Subject: Change to SAE/USCAR-45, Initial release, Revision Letter #4

Changes have been made to the USCAR-45 specification, Figure 9. This change takes effect immediately. Comments and questions can be sent to EWCAP@uscar.org.

FIGURE 9 - MEASUREMENT POINTS FOR FACE-TO-FACE (LEFT) AND BUTT SPLICE (RIGHT)

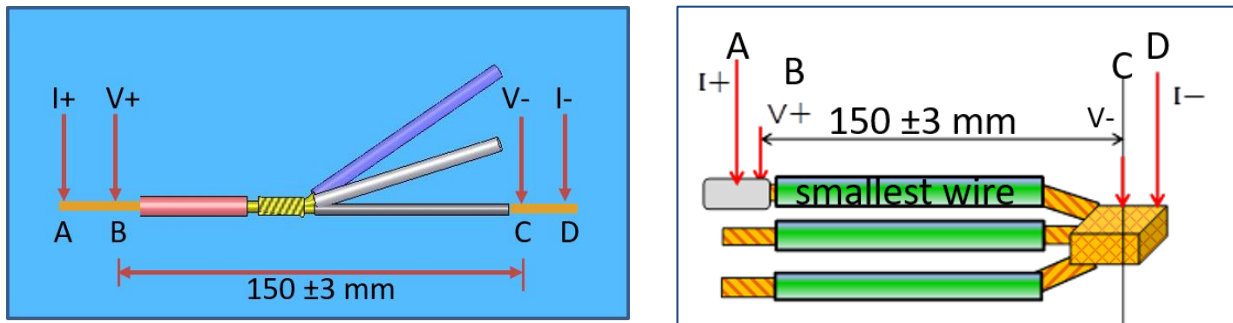
- 1) Step 2 in the instructions for preparing butt splices in section 4.7.4 gave unnecessary lab instructions.
- 2) Figure 9 illustrates probe positioning for a butt splice but not a face-to-face splice. An additional illustration is needed.

- 1) The sentence from 4.7.4 Step #2 "For butt splices, 150±3mm dimension includes the distance to the beginning of the nugget and then back for the same total 150mm length" is deleted.
- 2) Figure 9 is changed to add the face-to-face splice. The new Figure 9 is shown below.
